## PIC-EL II Board B4 (4/17/06) Error and Rework Instructions

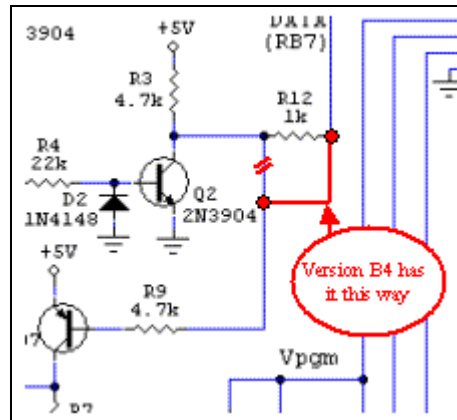
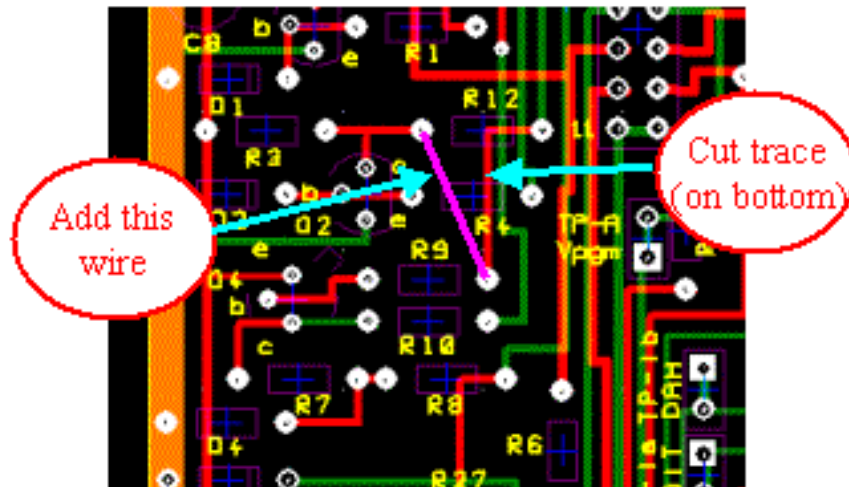
PIC-EL II Version B4 (4/17/06) has a minor error in a trace connection. The red wire in this diagram shows how it currently is. The wire from R9 to R12 should actually be connected to the Q2 side of R12.

Does it really matter? I don't think so. Very little current is flowing through these resistors so the voltage across R12 will be very small. It's easy to do so it's up to you.

If you want to modify your board to match the schematic you can cut one trace (on the bottom of the board) and add one jumper to fix it.
